Petition Number: 2017-097

Revision Log:

Date	Description	
07-20-17	First Review	
01-23-18	Second Review	
02-19-18	Third Review

Transportation Summary

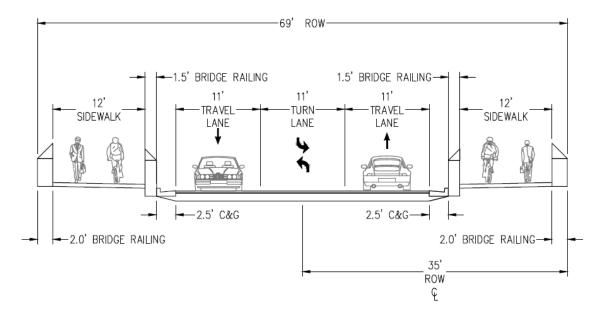
- 3. The petitioner should revise the site plan to show 2.5 foot curb and gutter, 8 foot planting strip and 6 foot sidewalk on existing Shopton Rd. The back of curb location is 41 feet from centerline of Shopton Rd.
- 4. The Coffey Creek bridge on Shopton Rd is to be replaced as part of a CNIP project. Street improvements should tie in to anticipated cross section below. Contact Felix Obregon at 704-432-5729 to discuss project specifics and coordination, as needed.
